UNITED STATES PATENT AND TRADEMARK OFFICE

APPLICATION NO.	FILING DATE	FIRST NAMED INVENTOR	ATTORNEY DOCKET NO.	CONFIRMATION NO.
10/552,427	07/24/2006	Frank Blase	LIP071	4404

Office Action Summary

DETAILED ACTION

Fig 1: Altered version of Holshausen (957) – Fig. 18

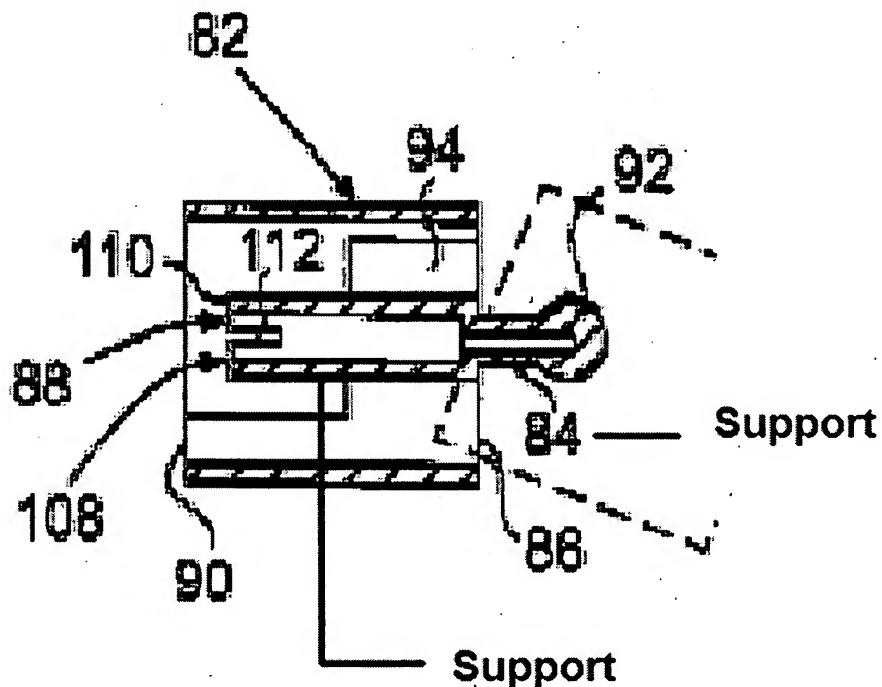
In regards to claim 5,

Cable-routing device according to Claim 1, characterized in that the joint elements are each supported by a support and the supports of the two joint elements of a link are offset relative to each other in a direction perpendicular to the longitudinal axis of the cable-routing device (seen in below figure).

Fig 2: Altered version of Holshausen (957) – Fig. 18

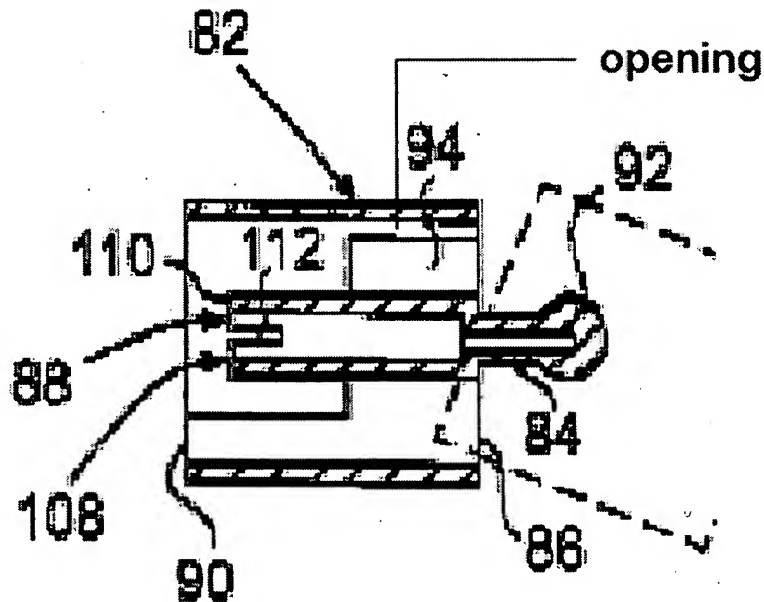
In regards to claim 8,

Cable-routing device according to Claim 1, characterized in that links are provided that are provided with at least one brace (94), extending transverse to the longitudinal direction of the cable-routing device and possibly bearing a guide element, and in that the brace displays at least one opening (seen in below figure) extending in the longitudinal direction of the cable-routing device, which can optionally serve to accommodate a line or other device within the cable-routing device.

Fig 3: Altered version of Holshausen (957) – Fig. 16

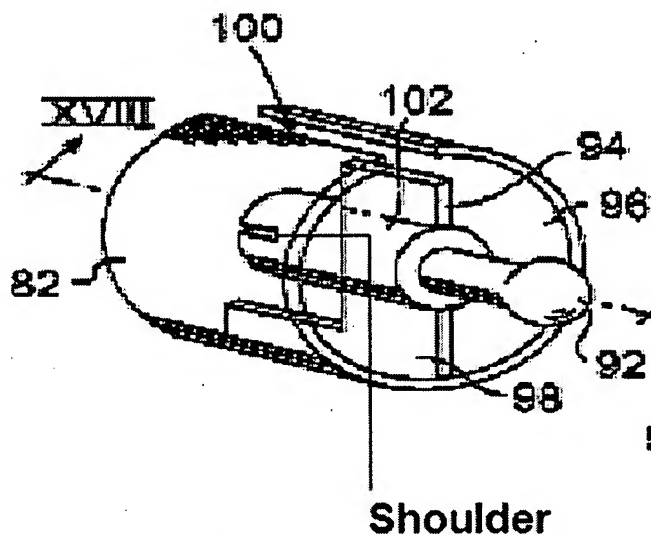
In regards to claim 12,

Cable-routing device according to Claim 11, characterized in that the opening displays a shoulder (seen in below figure), a distance away from the inside of the joint body receptacle, against which a tool can be positioned in the manner of a lever.
